Subject: TIME-SENSITIVE NOTICE REGARDING YOUR PACCAR MX ENGINE
ESB E159 – PACCAR MX Retrofit to MY2016 Standards - HVAC Bracket
EXPIRATION DATE: NONE
The VINs are listed on the back of this page

Technical Information Bulletin

E159

PACCAR MX Retrofit to MY2016 Standards – HVAC Bracket

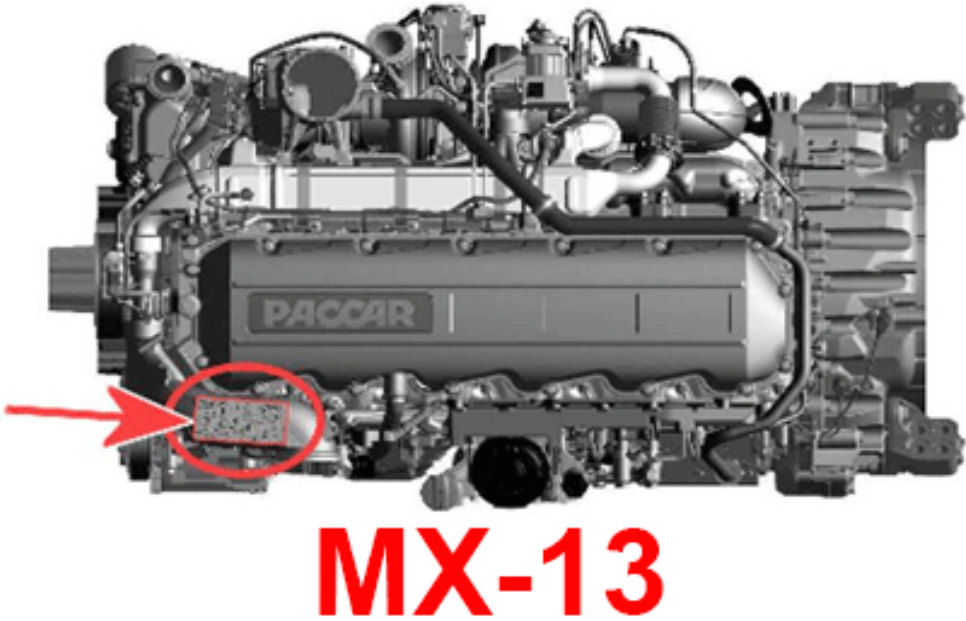
Pre-production PACCAR engines must have the following components replaced to remain emissions compliant:

- Tensioner pulley
- HVAC bracket
- Front engine mount
- Back pressure valve (BPV)
- Exhaust gas recirculation (EGR) valve
- Environmental Protection Agency (EPA) engine label
- Engine software update
